ATTACHMENT 1

MSW Comments on Bowdens Response to
Submissions and the Proposed Amendment
(Michael White, March 2022)

MSW Comments on Bowden's Response To Submissions Report and the Proposed Amendment

Figure 2: Biodiversity Study Area - does not extend to Lawsons Creek south of the site in R.W. Corkery & Co. 2022 Appendix 5 (EnviroKey) March 2022.

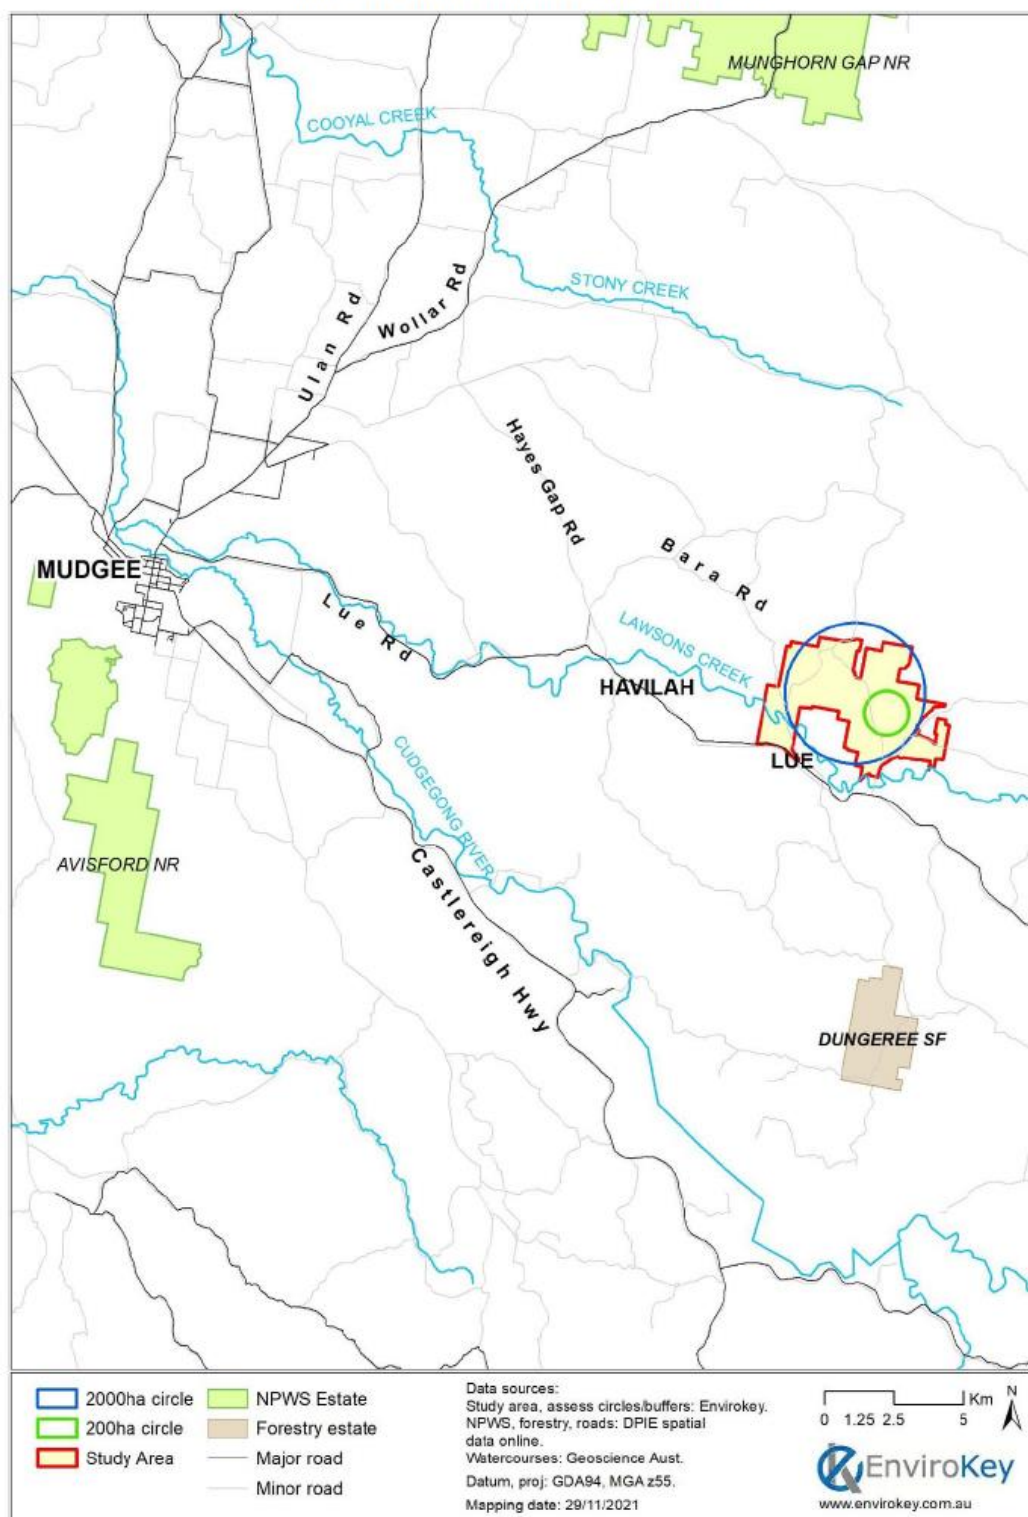
Volume 3 Part 9A – Biodiversity Assessment was updated in March 2022, however, EnviroKey were not advised that proposed disturbances might extend beyond previously surveyed areas due to the increased groundwater extraction proposed. In other reports, a permanent reduction in streamflows around the site due to reduction of rainfall run-off and a reduction in baseflow from groundwater is predicted (R.W. Corkery & Co., March 2022c, pp. ES-24). The disturbance is thus beyond the Study Area EnviroKey has been directed to consider (Figure 2).

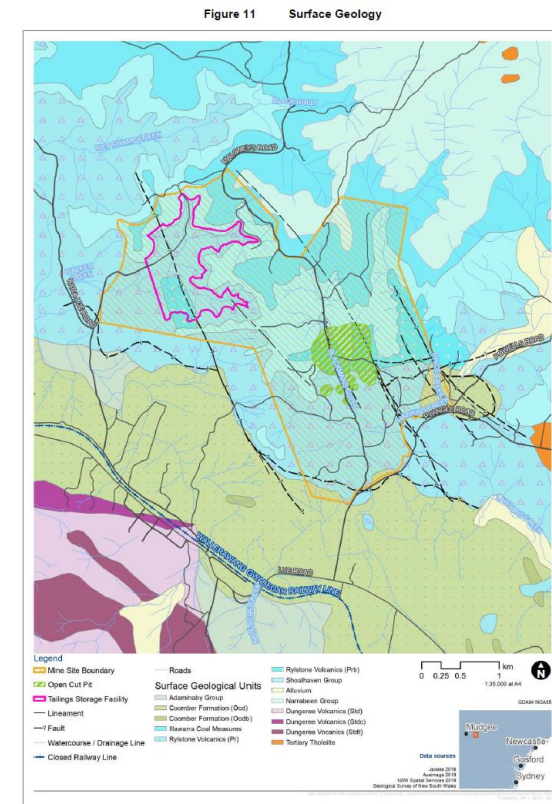
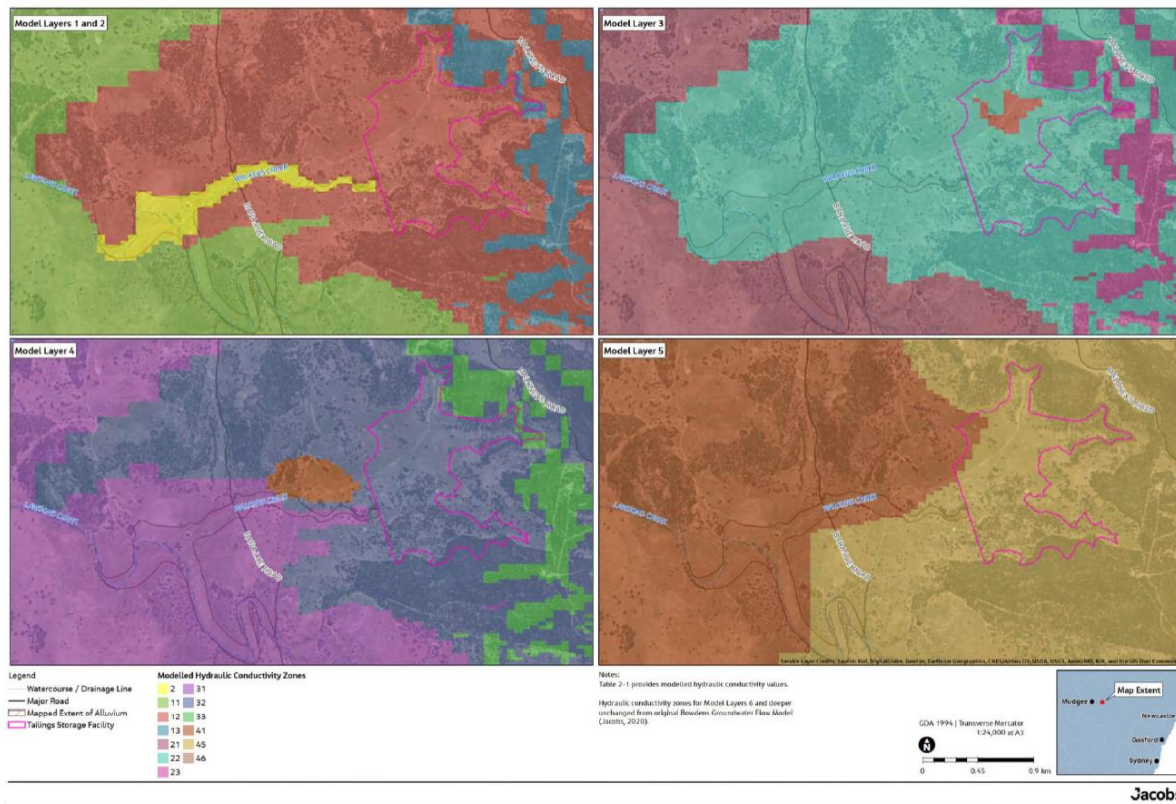
The lack of bores to inform (hydro)geological interpretation outside the site reduces confidence in the model outputs. The following figures show recent amendments to the groundwater model and compares these to the data that is presently available to inform these interpretations.

Figure 6: Modelled thickness of combined Layers 1 and 2 (R. W. Corkery & Co., 2022d, pp. 5-397)

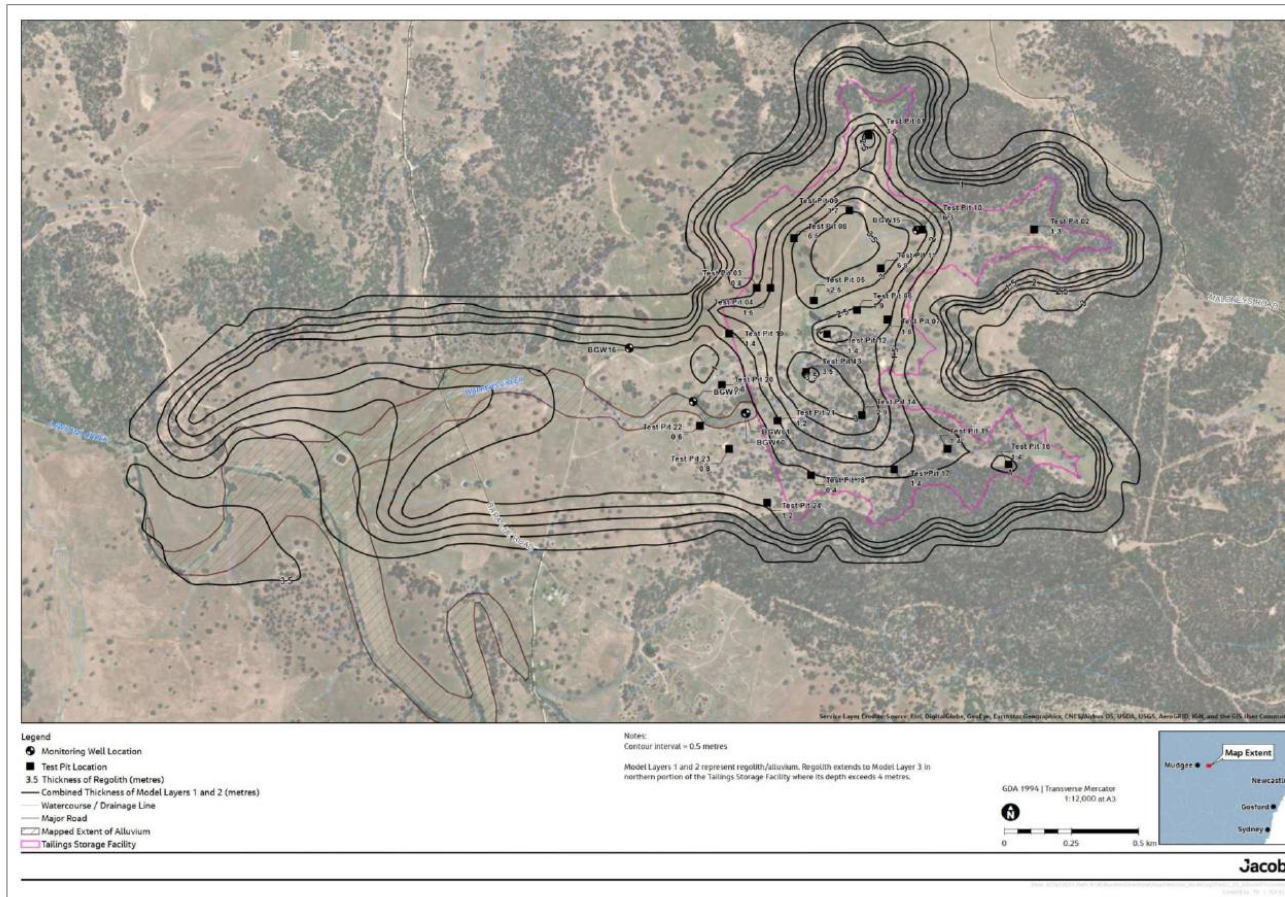
Figure 6 shows the modelled thickness of the upper two layers, but does not provide any guidance regarding the assumptions (e.g. geological logs) supporting this hydrogeological interpretation. Figure 7 and Figure 8 show the impact of the altered hydrogeology on modelled groundwater drawdown impacts; acid leachate is modelled to report to the pit in the outputs provided, not the creeks.

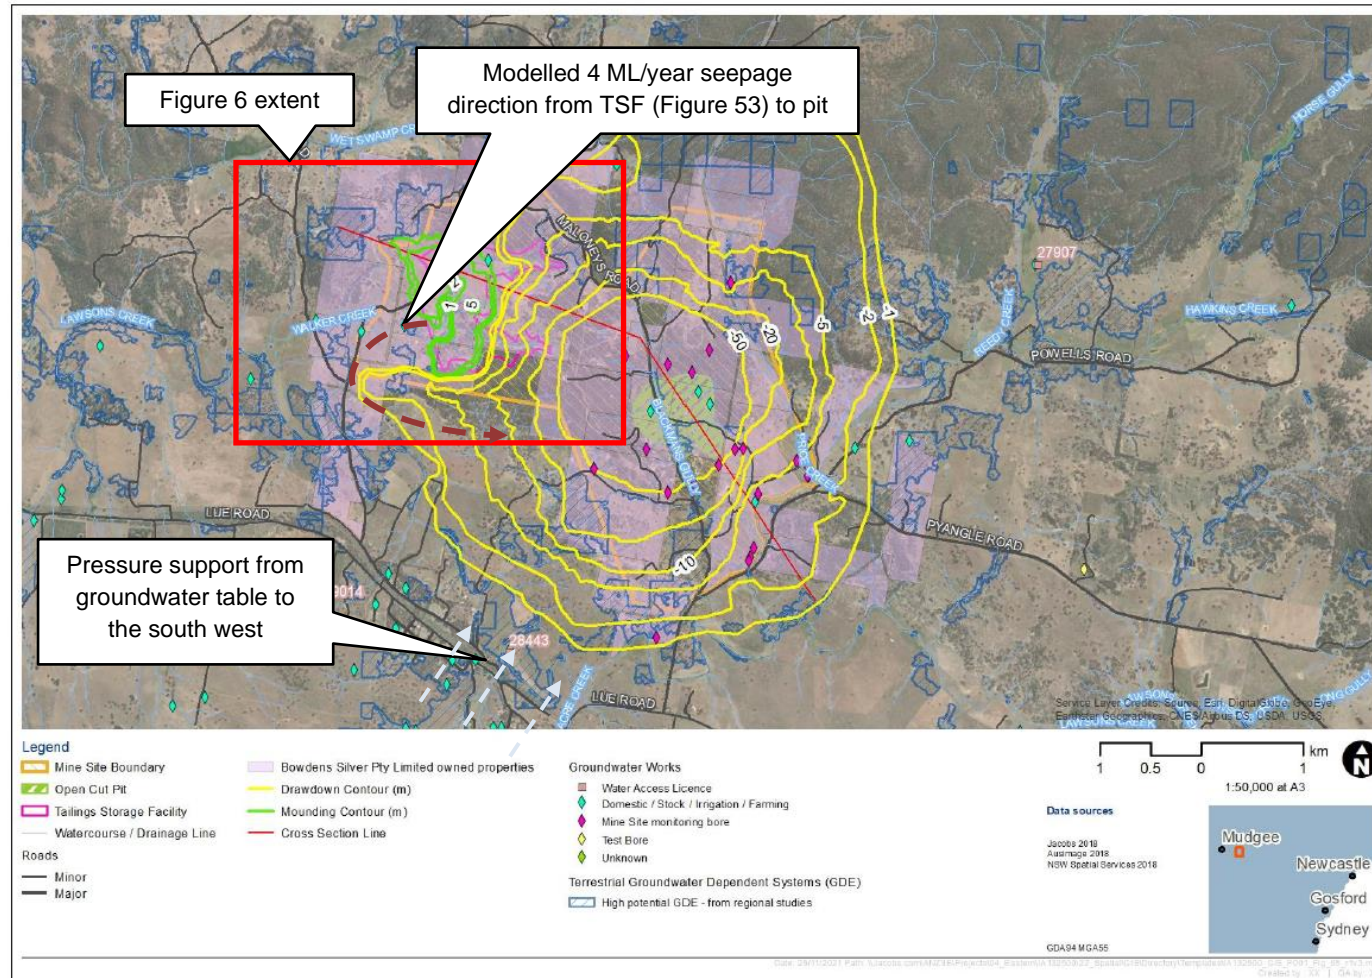
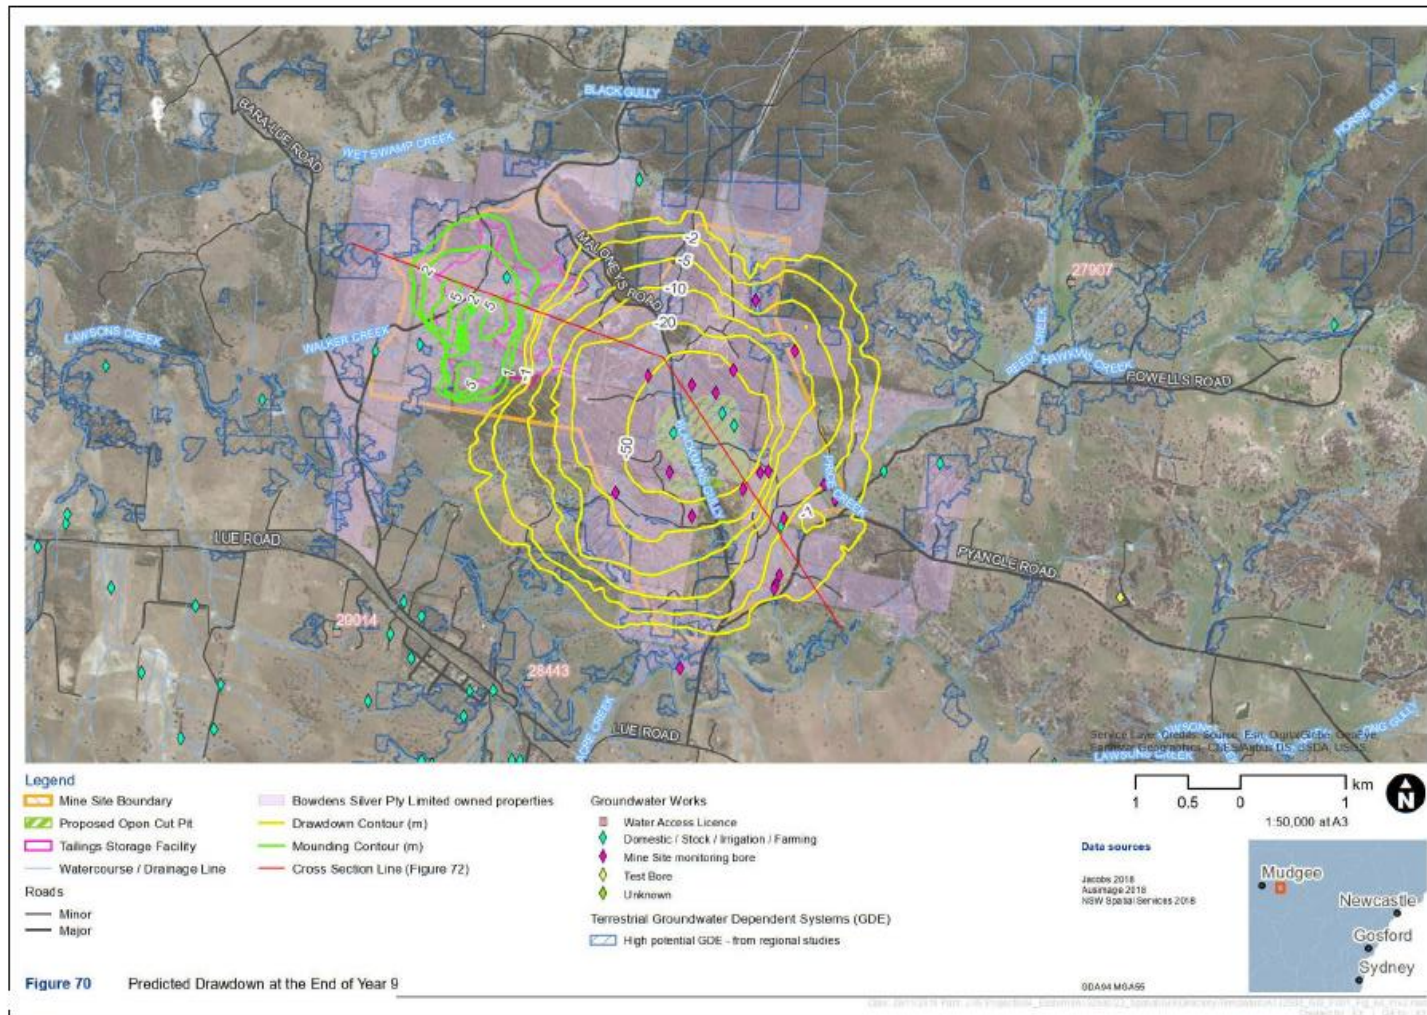
¹ Bituminous liner TSF Design Option 1, Figure 53 (assumed mislabel) Figure 18, and Figure 16 for planned volumes reaching Lawsons Creek at certain locations (R. W. Corkery & Co., 2022d)
